Invitation for Bid No. 2025-030

Detention Center Sewer Screening

ADDENDUM No. 1

ISSUE DATE: March 26, 2025

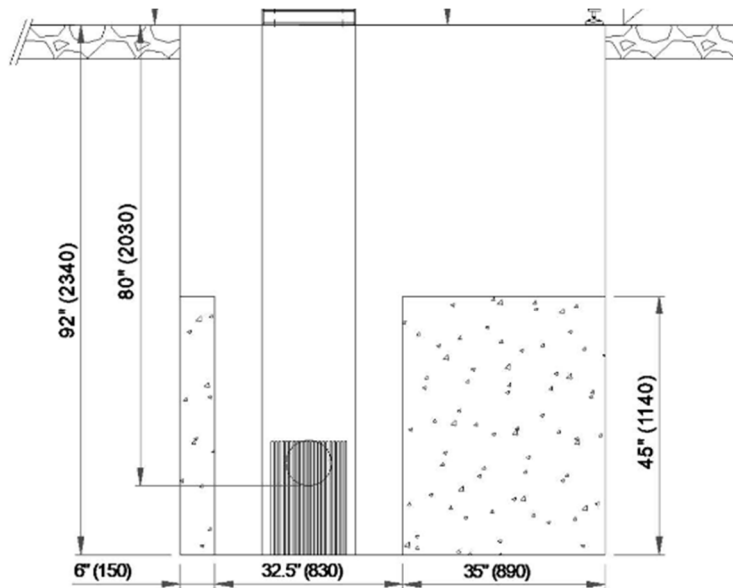
14. (P200) Please provide the dimensions for the detail view of the "Sewer Screen Equipment – Basis of Design."

Answer:
